Contract #: 04-0120F4  
 Cty: SF/ALA Rte: 80 PM: 13.2/13.9  
 File #: 69.25B

## QUALITY ASSURANCE -- NON-CONFORMANCE REPORT

**Report No:** NCR-000542

**Reference Description:** Deviating from Approved HSR during Heat Straightening, L6W

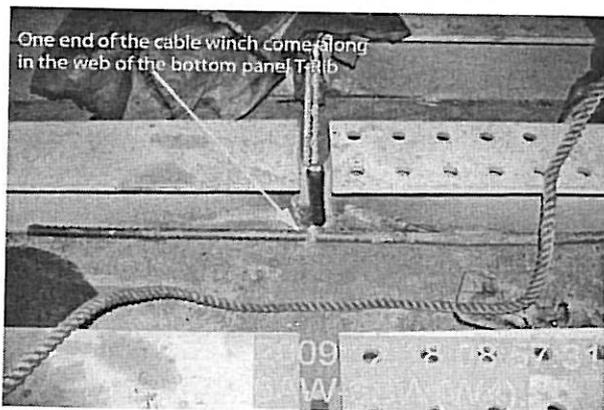
The Caltrans Quality Assurance (QA) Inspector observed ZPMC personnel aligning the Longitudinal Diaphragms (LD) 6AW (LD16E) to 6BW (LD10A) by utilizing an approved Heat Straightening Report (HSR). ZPMC personnel rigged a hand operated cable/chain winch (come-along mechanical device) at the flange of LD10A and anchored it behind the web of the T-Rib at the Bottom Panel (BP) of 6AW to 6BW. This equipment and methods were not described in ZPMC's internal HSR procedure. Additional information identifying this non-conformance issue is listed below.

-The LD's were located at 6AW to 6BW splice weld at W4.

-The 6AW LD is identified as: LD16E

-The 6BW LD is identified as: LD10A

-The HSR was identified as HSR1 (B)-7992 Rev. 0, dated 11th Dec. 2009.

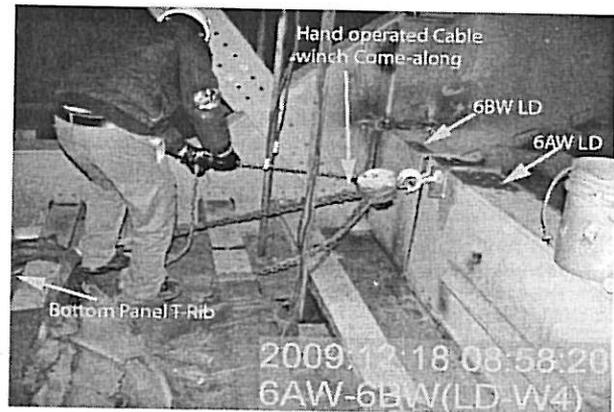
ZPMC Heat Straightening Report; "HSR1 (B)-7992 Rev. 0 dated 11th Dec. 2009."

Standard Specifications (99) section 55-3.02 Straightening of Material; "If straightening is necessary, it shall be done by methods acceptable to the Engineer. Details for the methods proposed for straightening shall be submitted in writing to the Engineer prior to their use."

Reference Resolution: Since the HSR depicted a mechanical force being used ZPMC and ABFJV agrees that this is acceptable. In lieu of the jack, ZPMC used other mechanical means in this case chains during heat straightening. Since the HSR depicted a mechanical force being used ZPMC and ABFJV agrees that this is acceptable. ZPMC requests that this NCR be closed.

Provide NDT indicating weld soundness.
